MFN 06-262
Supplement 4

Subject: **Modified Reactor Building/Fuel Building Truncated Model,
SER-ESB-038 Rev. 5**

**Shimizu Engineering Report SER-ESB-038, Rev. 5,
“Modified RBFB Truncated FE Model Analysis Data,”**

Project	General Electric Company ESBWR Project	Shimizu Document No.	SER-ESB-038
Title	Modified RBFB Truncated FE Model Analysis Data	Rev.	5
		Issued Date	9/22/06
		Revised Date	1/9/07

Figure C-19 Element Forces Comparison NASTRAN to ANSYS (F3 Wall: Out-of-plane Shear [MN/m])

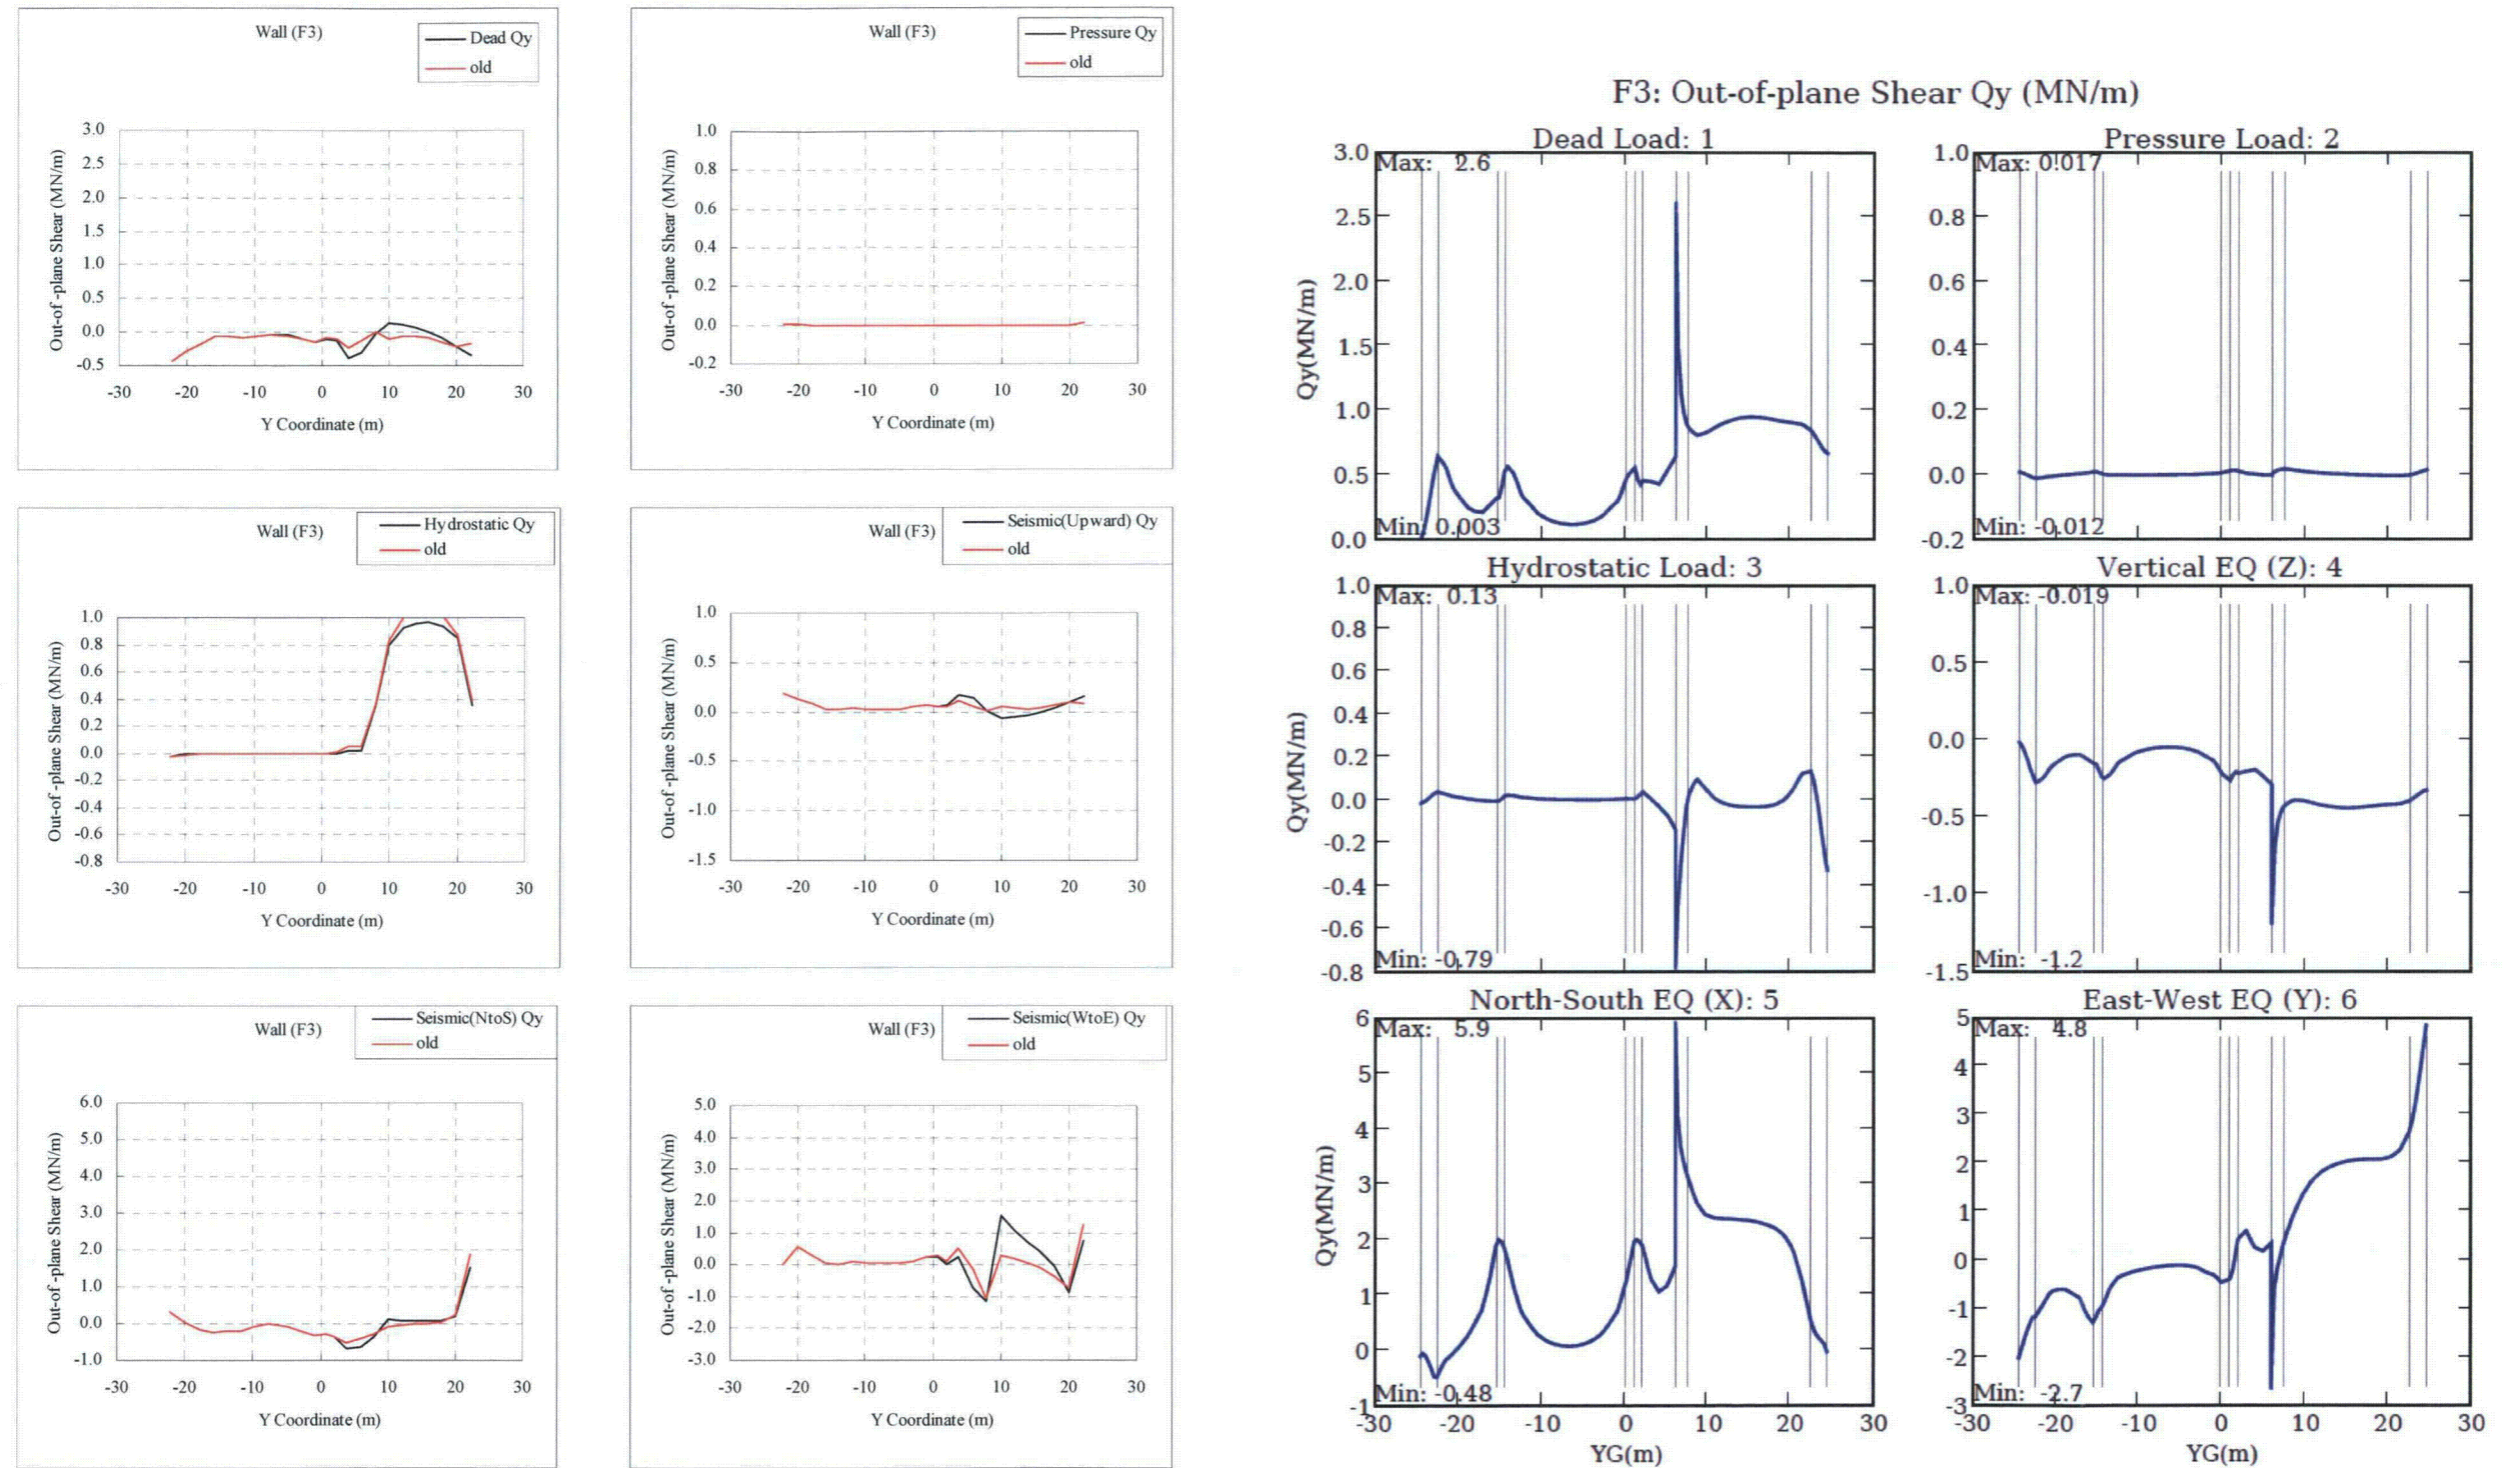
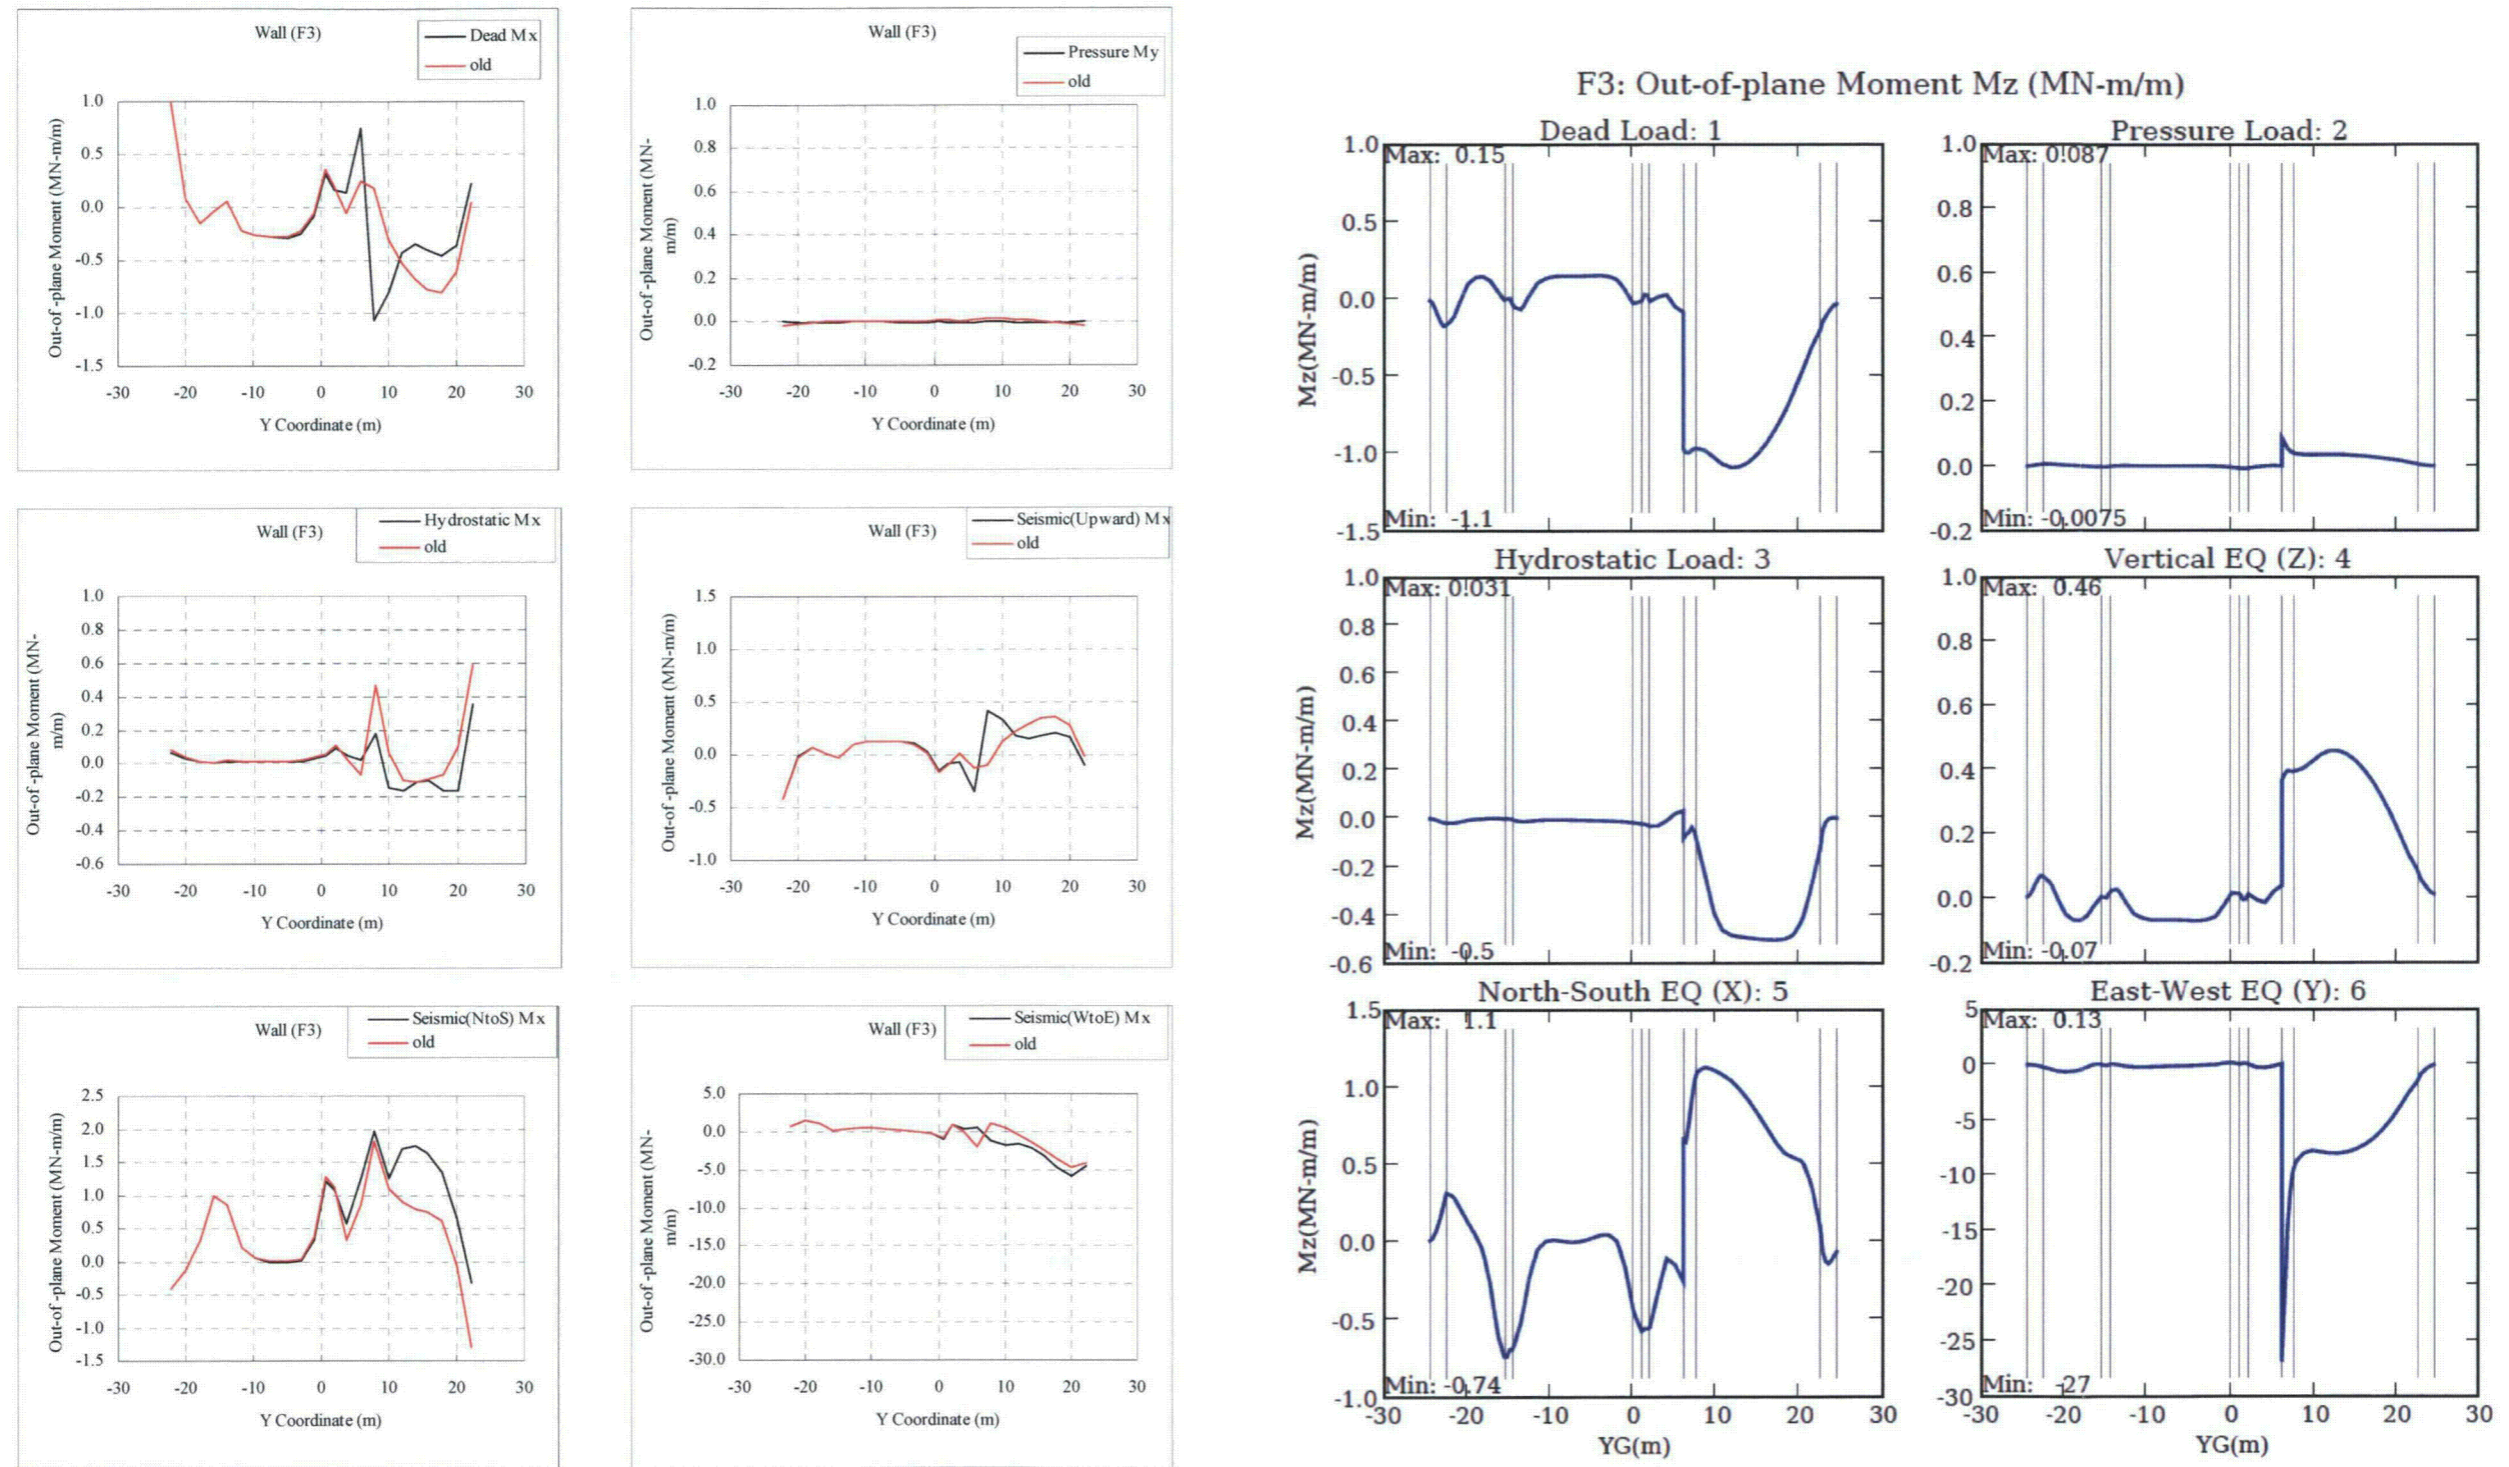
- iii) *The differences of magnitude of forces appeared on basemat inside pedestal:* The result of re-analysis using the updated model shows better agreement. In case of seismic load the magnitude of forces has to be re-compared because BNL's soil spring may not be adequate as pointed out above 3).

- iv) *The differences of magnitude of forces appeared on outer wall of Fuel Storage Pool (FSP):* For the out-of-plane shear forces and moments on RA and F3 wall located around FSP in case of Hydrostatic load, BNL's results are lower than those of GE. GE assumes the some part of differences comes from the difference of estimation levels between both models as pointed out above 8). In order to have a better understanding of the differences, GE would like to request BNL to confirm the input data for Hydrostatic load.
